Re: PLUS Review – 2012-04-02; Castaways Bethany

The following is the May 17, 2012 letter from the Office of State Planning Coordination with the applicant's response highlighted.

Based upon your application you have ask the PLUS reviewers to consider a rezoning of the 38.98 acres from C-1 and MR to C-1, AR, and MR for a proposed RV & Cottage resort with a water park facility.

Figure 1: SWMP mapping in the immediate vicinity of the proposed project

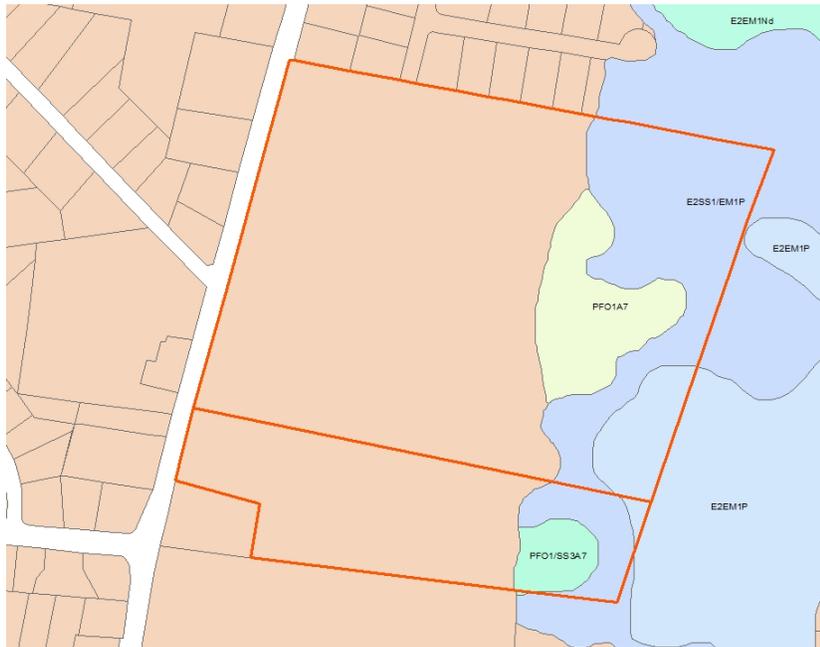
- According to the Statewide Wetland Mapping Project (SWMP) maps, non-tidal palustrine (PF01A7) and tidally-influenced estuarine wetlands (E2SS1/EM1P & E2EM1P) were mapped in the immediate area of the proposed project (See figure 1).

Acknowledged

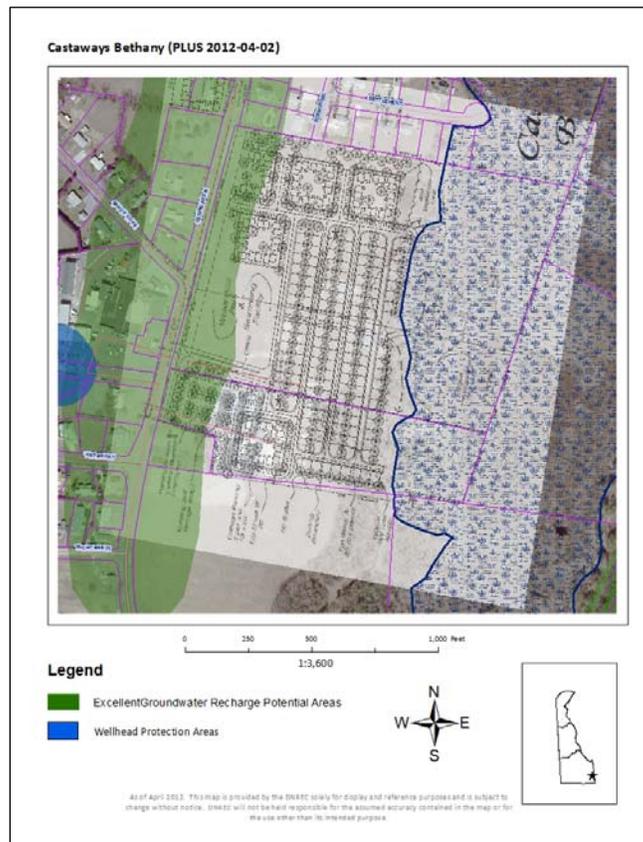
- The western portion of the project falls within an area of excellent ground-water recharge potential for Sussex County (see map).

Acknowledged

Figure 2: Soils mapping in the immediate vicinity of the proposed project area

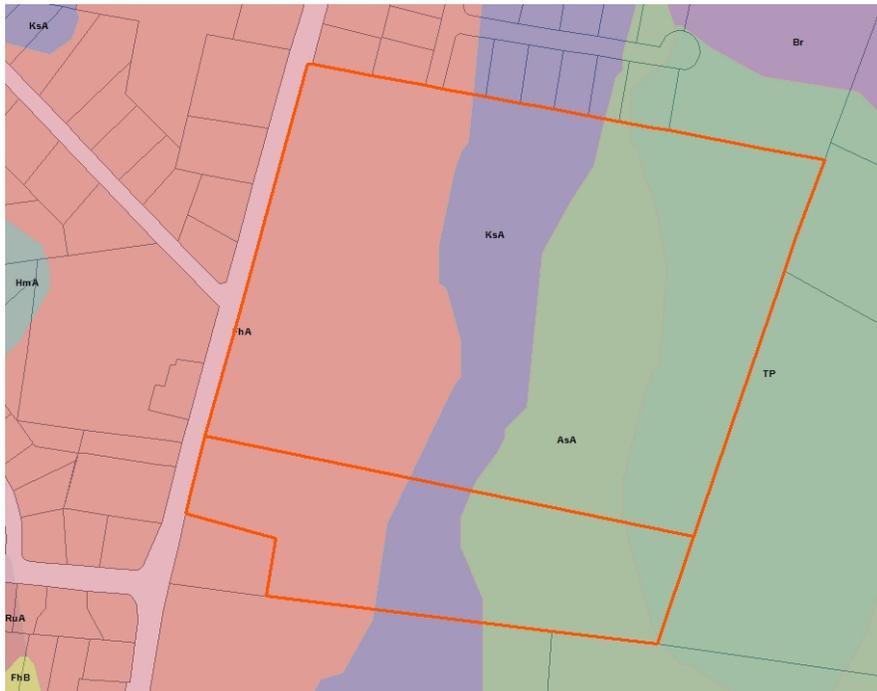
- Based on soils survey mapping update, Fort Mott (FhA), Klej (KsA), Askecksy (AsA) and Transquaking-Mispillion (TP) were mapped in the immediate vicinity of the proposed project. Fort Mott is a well-drained upland soil that has few limitations for development. Klej is a somewhat poorly-drained (transitional soil between uplands and wetlands) soil that may contain both upland and wetland (hydric) soil components. Askecksy and Transquaking-Mispillion are poorly to very poorly-drained wetland associated (hydric) soils that have severe limitations for development and should be avoided - filling and grading these soils may increase the potential for onsite and offsite flooding events (See figure 2).

Acknowledged
